Wiltshire Council Planning Consultation Response

Application No: **PL/2026/02266**

Erection of 9 residential dwellings, access, parking, gardens, landscaping and associated works
Land south of Park Street, Warminster

Access onto Park Street

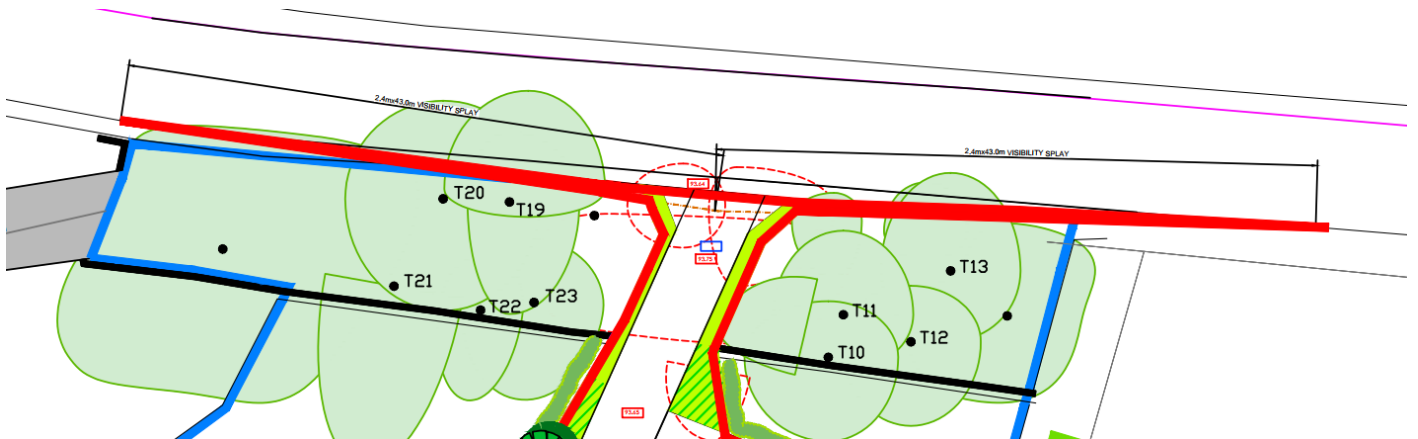
The 3D sketch view suggests that this will be relatively low key. However, I note that my Highway's colleague says 'The submitted plans show visibility splays of 2.4m x 43m, which are sufficient for the context and meet National Guidance. The access and splays would be likely to require the removal of trees/vegetation in the vicinity, as well as excavation of the land to address level differences'.

Given my previous comments, and those of my Highways colleague, I would like to see a more detailed plan regarding the proposed access onto Park Street. If the number of trees to be removed could be confirmed (the proposed plan suggests 3 (if that is what the red dashed lined circles indicate) and also whether there would need to be excavation. Also, are pavements proposed?

If you are minded to grant consent, I would suggest that consideration is given to a more detailed access plan, that clarification is sought re pavements and that a materials schedule is approved (to ensure the quality of the scheme is not eroded further down the line).
